# DRAINAGE INFORMATION SHEET

PROJECT TITLE: Sirloin Stockade ZONE ATLAS/DRNG. FILE #: E-14/104

RE: REVISED DRAINAGE PLAN FOR SIRLOIN STOCKADE @ 6225 FOURTH  
STREET, NW (E-14/D4) RECEIVED DECEMBER 19, 1986

RE: DRAINAGE PROBLEMS, SIRLOIN STOCKADE RESTAURANT  
6225 FOURTH STREET, NW (E-14/D4)

GRADING AND DRAINAGE PLAN

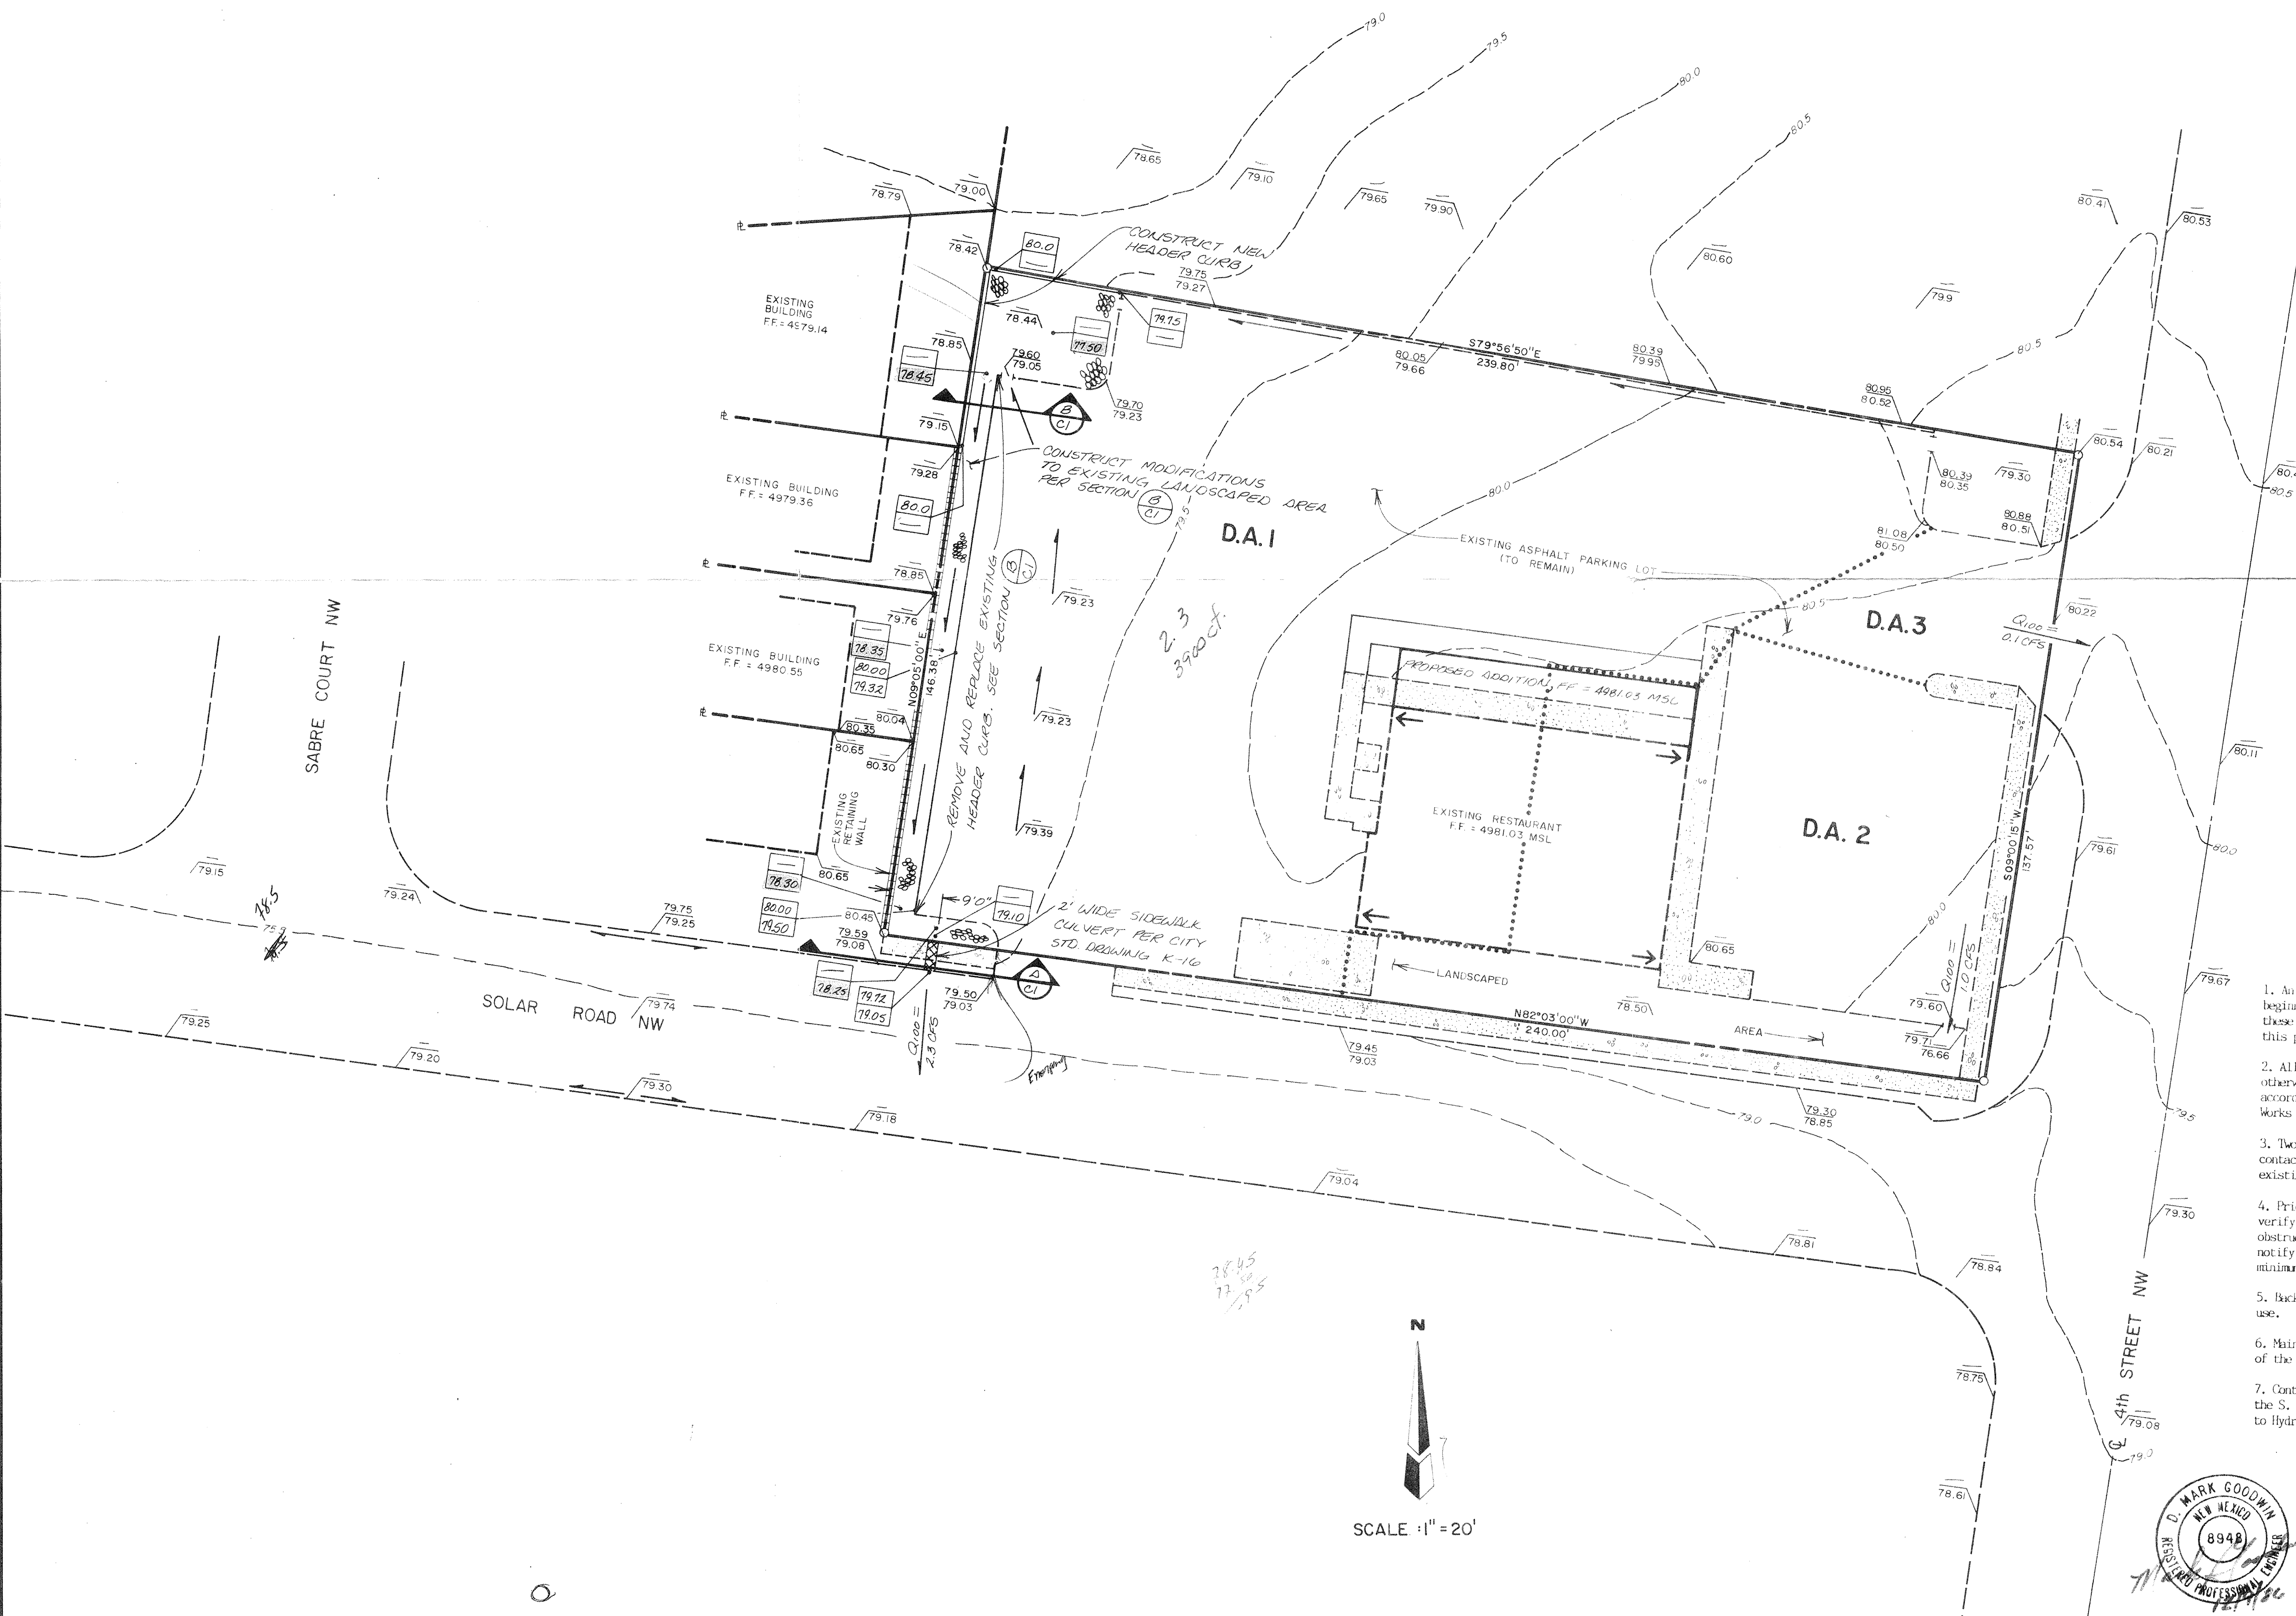
1. New top of wall grades of 4980.0 elevation were not constructed,
2. The emergency spillway elevation should have been located at the driveway into Solar Road.
3. Emergency spillway as it exists is directly in front of Mr. Wayne Ciddio's backyard, thus causing flooding within his backyard.

1. raise the header curb by twelve inches all along the west boundary and for approximately forty feet along the north boundary, starting from the northwest corner;
2. remove the plastic liner from the graveled swale ditch, and regrade the ditch to drain to the street; and
3. plant a ground cover or grass in the ponding area and swale ditch to improve the permeability of the soil.

Please provide this office with confirmation as to what will be done to correct this problem. Also, you are welcome to have a copy of our survey notes.
